DESIGN AND CONSTRUCTION MANUAL DESIGN MODIFICATION REQUEST

PROJECT NAME: Longview Mansion – Parking Lot Addition

RE: PL2023291 – Longview Mansion – Parking Lot Addition

EXHIBIT
EX-04

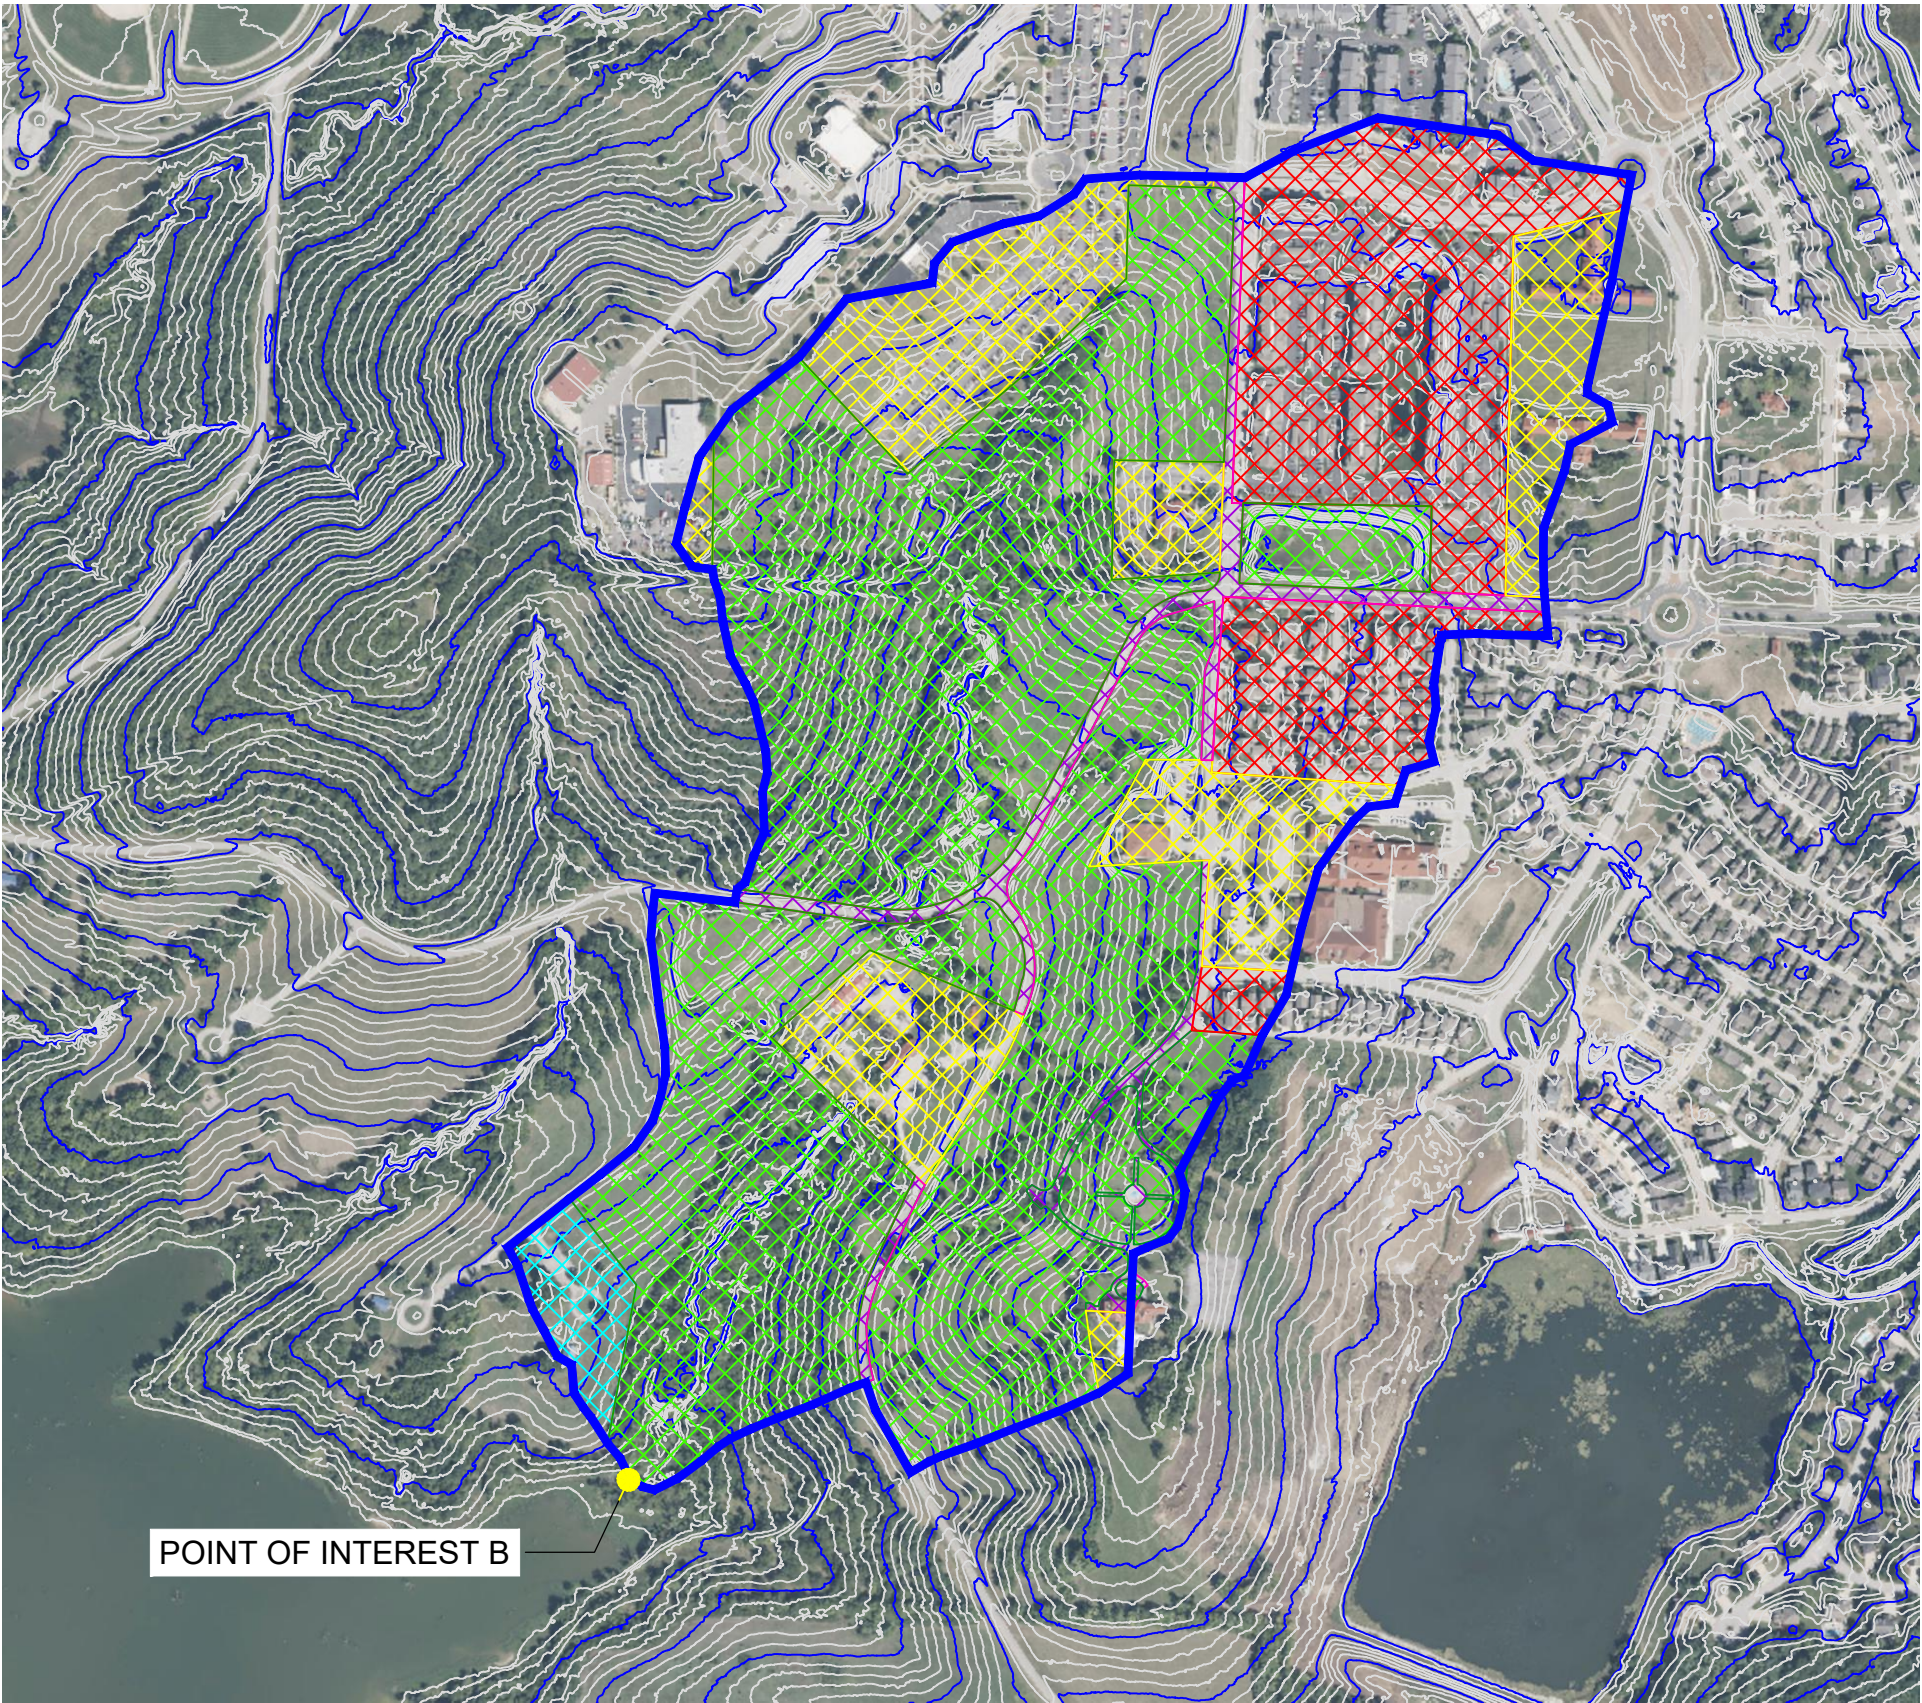
There is an existing unnamed tributary between the county road and the lake that collects stormwater for a watershed of 133.66 acres, for which the proposed site accounts for ~0.75% of the watershed. This tributary was analyzed in existing conditions with a 5' bottom width and 8' depth with 3:1 slopes, and was determined to have flowrates at the point of entry to the lake (Point of Interest B, see Exhibit EX-04) as shown in the table below:
